## SUMMARY OF CONCERNS IN RELATION TO THE PROPOSED NORTHCONNEX TUNNEL

**This is an objection to many aspects of the proposed NorthConnex tunnel.**

## SECTION A: THE CONNECTIVITY OF NORTHCONNEX SOUTHERN VENTILATION FACILITY AT THE SOUTHERN INTERCHANGE, THE SOUTHBOUND TUNNEL IN PARTICULAR

MOTORWAY OPERATIONS COMPLEX - SOUTHERN VENTILATION FACILITY - SECTIONS  
M1-M2-5000-DR-JD-0525

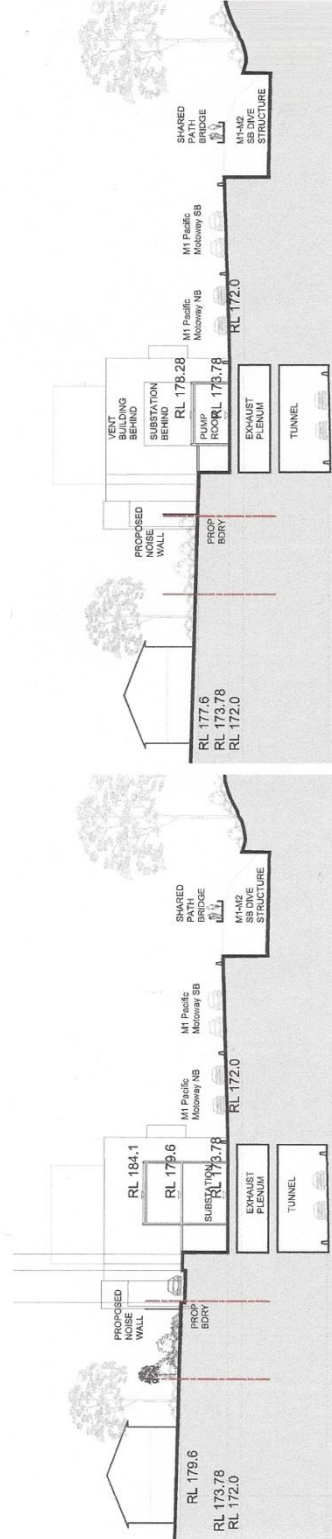
6. *EIS Volume 4, Technical working papers Urban Design, 8.0 Landscape Design*  
EIS Page 176 is the diagram "Motorway Operations Complex – Southern Ventilation Facility – Site 1-1". *Page 13 below* The diagram does not show any connection to either the northbound or southbound tunnel. In the same Landscape Design section, EIS Page 182 is the diagram "Wilson Road Tunnel Support Facility –Section" *Page 14 below* which clearly shows the connection to the tunnels. In the same Landscape Design section, EIS Page 189 is the diagram "Northern Ventilation Facility – Landscape Concept Section". *Page 15 below* This also clearly shows the connection to the tunnels.

- Diagrams need to be provided showing the inter-relation between the shaft, the ventilation outlet and the motorway operations centre with a clear description of what is to be constructed and how it will operate.
- The community needs irrefutable evidence that the polluted air from the southbound tunnel exit portals will not be allowed to flow like an invisible sewer through West Pennant Hills, North Rocks, Carlingford and Beecroft.
